Building and Development Tribunals—Decision

Appeal Number: 3-08-038

Appeal under section 4.2.9 of the *Integrated Planning Act 1997* (IPA) against the decision of the Assessment Manager issued on 22 May 2008 to refuse an application for Building Development Approval (Ref Number 20087355) for additions to an existing Class 10a Outbuilding on the subject site, as directed by Gold Coast City Council's concurrence agency response of 20 September 2008 (Ref Number BLD:2714678).

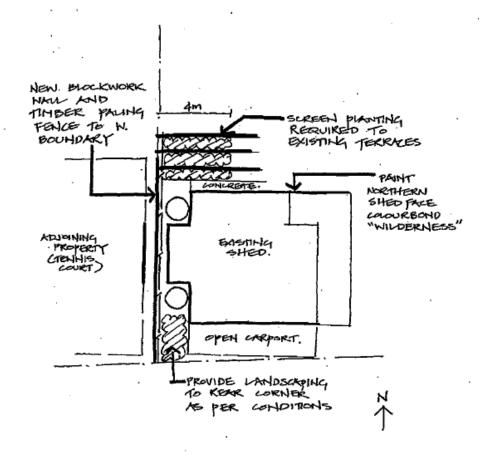
the addition to the existing shed being the "as built" Class 10a carport to the rear of the existing shed can be sited at a distance of .20 m from the southern boundary;

- the addition to the existing shed being the "as built" Class 10a extension to the side can be sited at a distance of 1 m from the western boundary;
- the two Class 10b rainwater tanks located either side of the shed extension can be sited approximately 1 m from the western boundary;

- a blockwork retaining wall to be constructed along the western boundary, from the south-west corner of the property to join up with the existing brick retaining wall:

- a new 1.8 m high timber paling boundary fence to be constructed on top of the blockwork retaining wall equal to the length of the tennis court. The construction of this fence should meet the requirements of the pool fencing standards where adjacent to the swimming pool;

- the northern wall of the existing shed shall be painted a colour of similar shade to colourbond "Wilderness";
- landscaping to be carried out in the existing retaining wall terraces on the northern side of the shed as
 follows terraces to be excavated and backfilled with topsoil to a minimum depth of 500 mm for a
 minimum distance of 4 m from the western property boundary. Terraces to be planted with screening
 plants which will grow to a height of 3 to 4 m (suitable species include Lilypilly and/or Golden Cane).
 Plants are to be a minimum of 1.5 m height at installation and be spaced maximum 1 m apart;

- landscaping to be carried out to the west of the open carport in the south west corner of the property
 as follows provision of minimum 300 mm depth topsoil and screening plans which will grow to a
 height of 5 6 m (suitable species include Lilypilly). Plants are to be a minimum of 1.5 m height at
 installation and be spaced maximum 1.5 m apart.

(Note: please refer to the attached drawing for further details of conditions).
